Village of Winnetka

Design Review Board/Sign Board of Appeals Regular Meeting

June 19, 2025 at 7:00 PM
Winnetka Village Hall Council Chambers
510 Green Bay Road

On June 19, 2025, the Design Review Board (DRB) is scheduled to hold a continued a public hearing on an amended application submitted by Metra (the “Applicant”), as lessee of the property located at 1065 Gage Street (the “Subject Property”), which is owned by the Union Pacific Railroad (the “Owner”). The Applicant has submitted amended plan options for the proposed elevator towers and is seeking approval of a Certificate of Appropriateness to allow renovation of the existing train depot and train platform and construction of a new pedestrian bridge, new accessible ramps, new stairs and elevators to the train platform, and new warming shelters on the Subject Property.

Option 2 Improvements

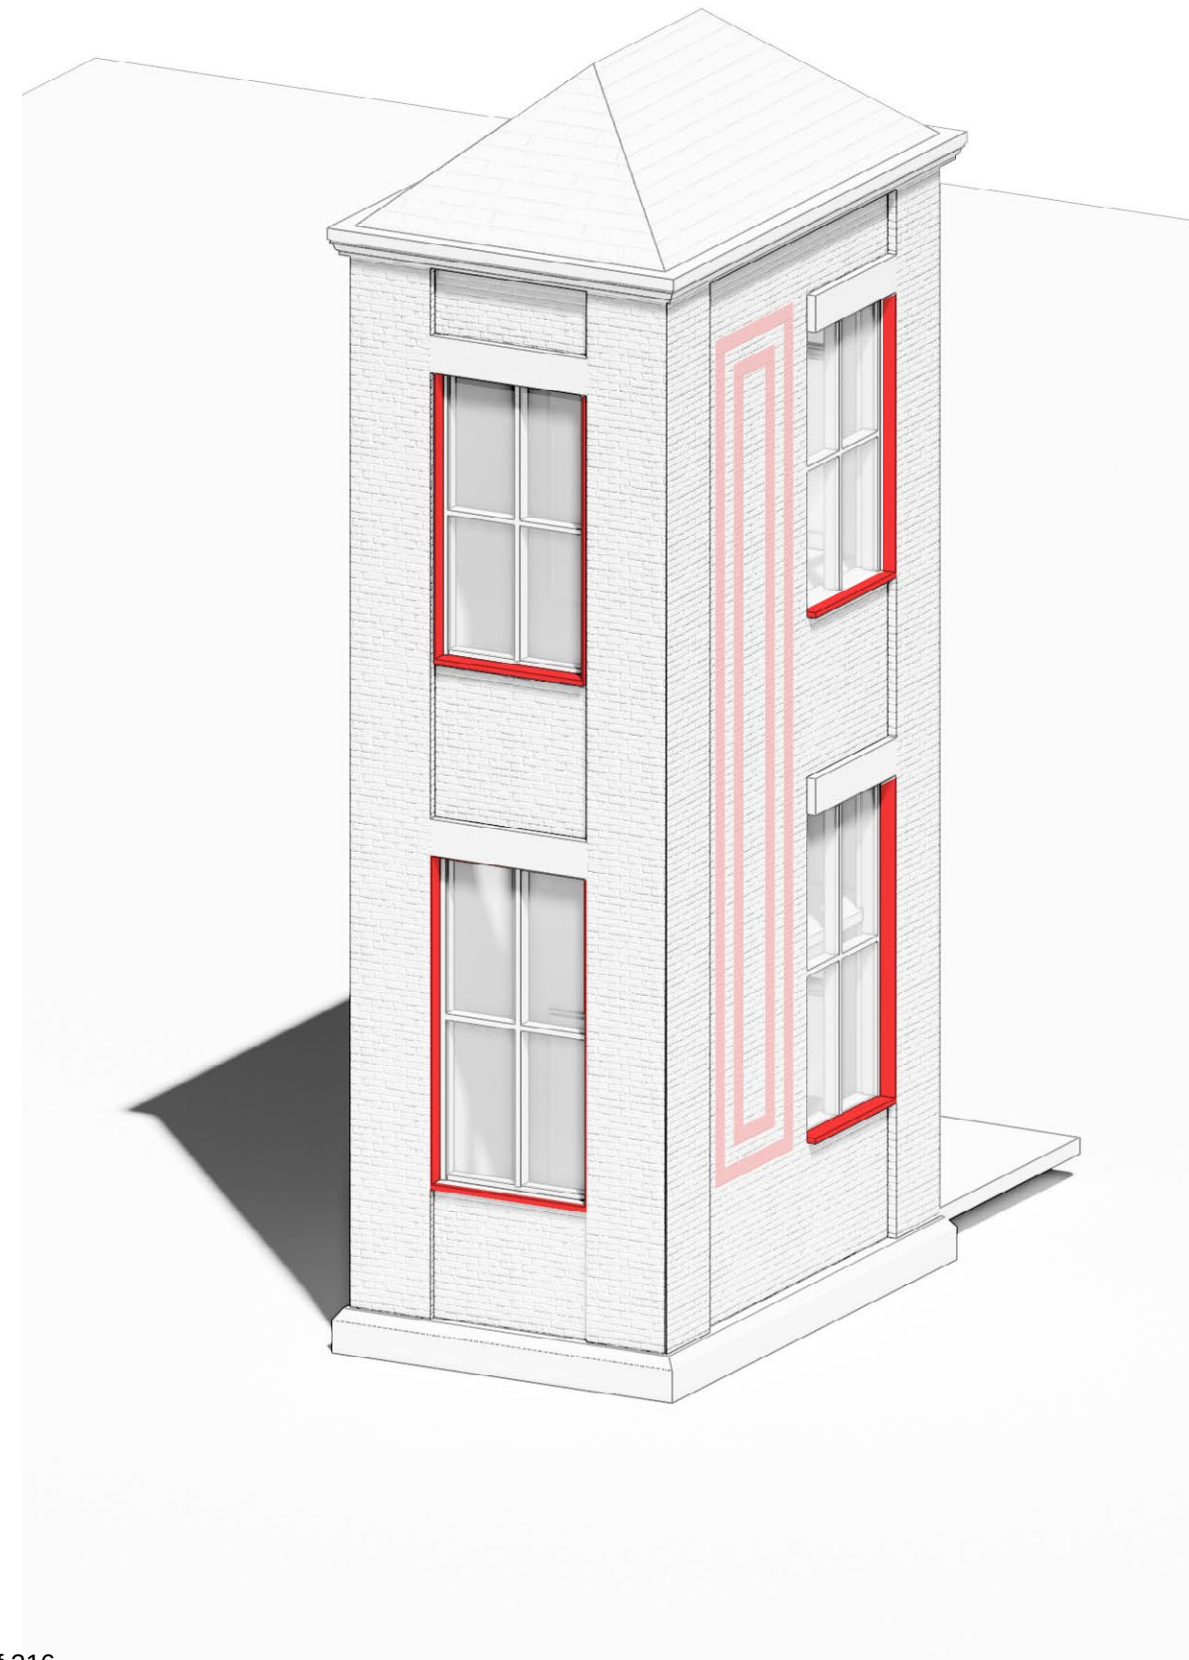
- Window proportions could be refined for better balance.
- Consider enhancing or integrating the lintel to strengthen the opening.
- Wall surface appears flat : opportunities for added depth or relief.
- Explore ways to express brick in a contemporary manner through detailing.

- *In addition to Option 1*
- Windows vertically elongated to further emphasize tower's verticality
- Pattern added to side surface to activate empty space and create visual interest

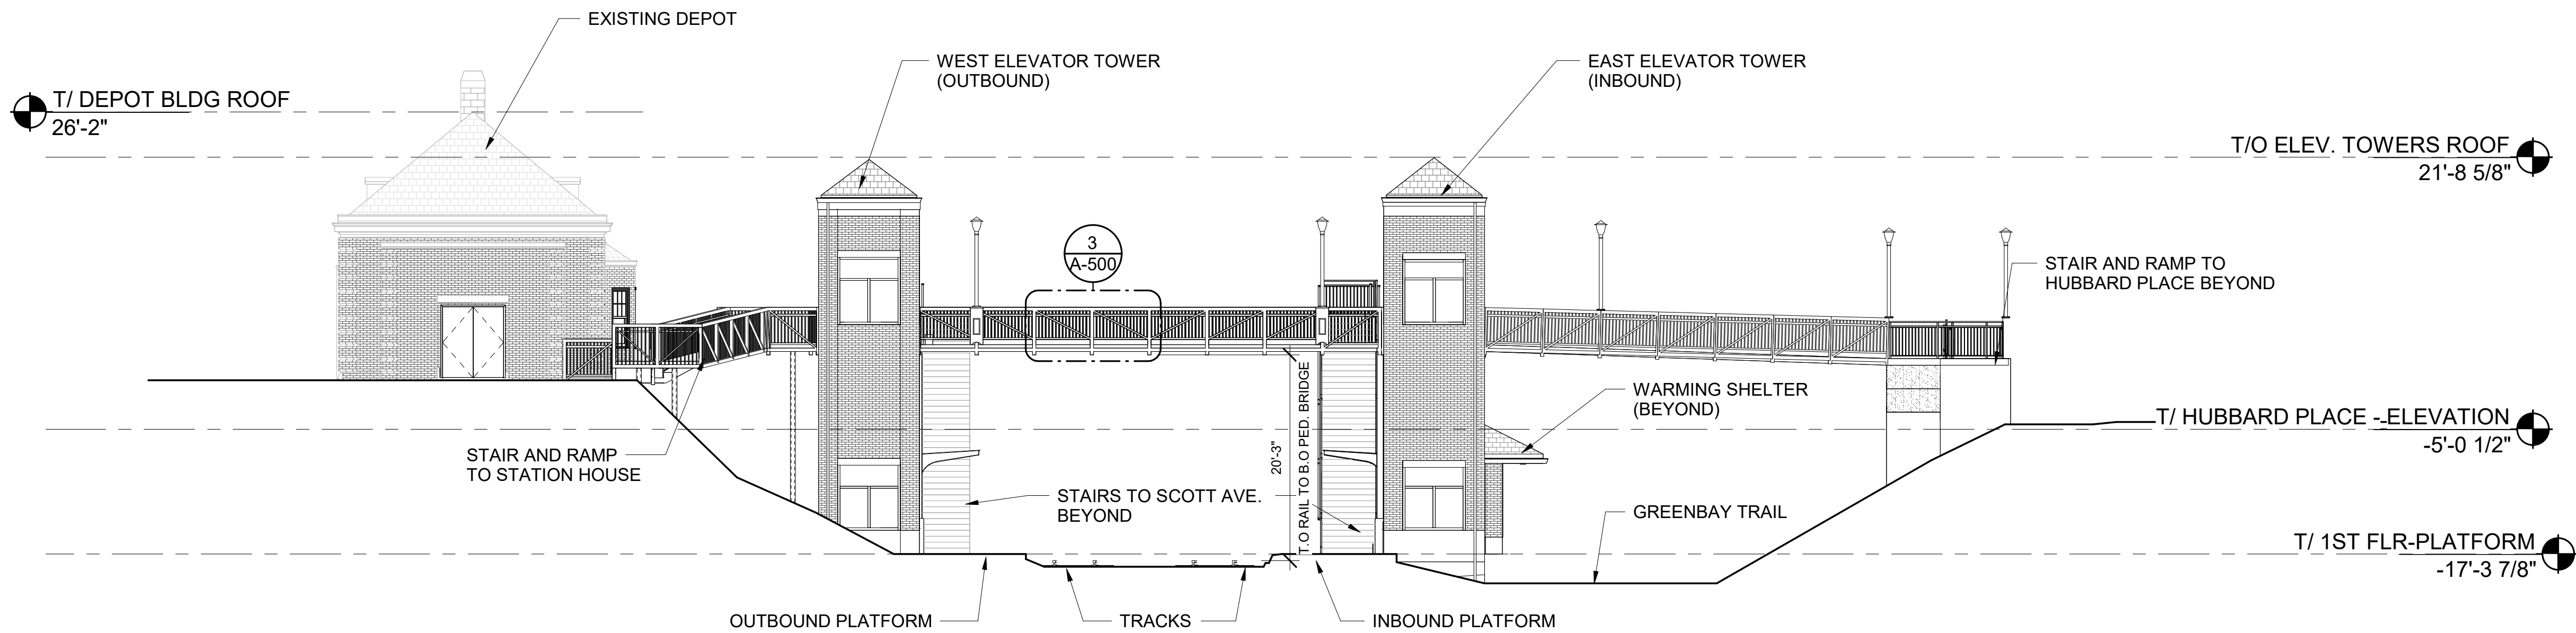
TYLin responded to this comment during the Design Review Board meeting on 4/17/25 that the design of the elevator towers was modified per direction of the State Historic Preservation Office (SHPO) to differentiate the towers from the architectural period of the historic depot building. The current design of the elevator towers (2021/2024) received approval from FTA and concurrence from SHPO.

Prior design of the elevator towers (2020) reflects modifications that the Winnetka Design Review Board members requested, however, the SHPO rejected the previous proposed tower design due to imitating or copying overall elements and not differentiating new construction from that of the historic depot.

The Village of Winnetka, the Winnetka Historical Society, SHPO, and FTA representatives were present at the Consulting Parties Meeting held on 1/7/2021 and agreed upon the modifications to the elevator towers.

Initial Proposed Design

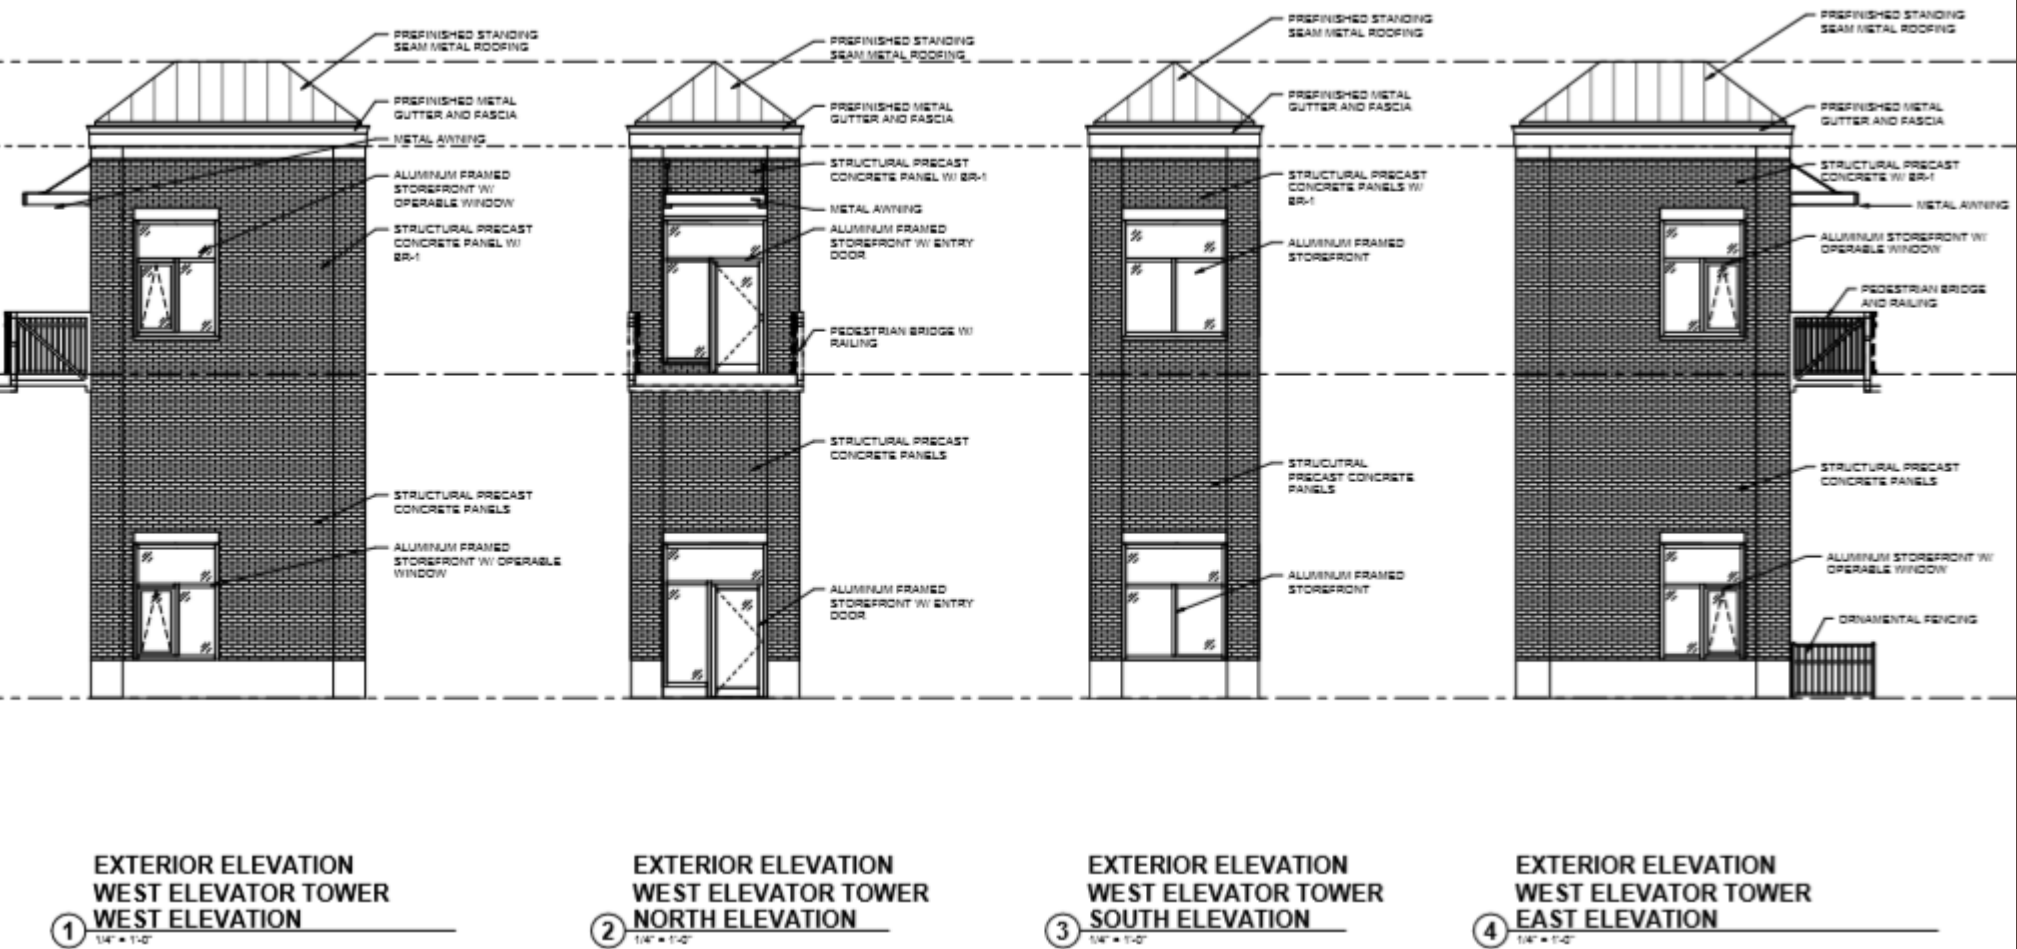
The roof style of the elevator towers is different from the one on the depot. They are seam metal with **lower hip and no eaves**.
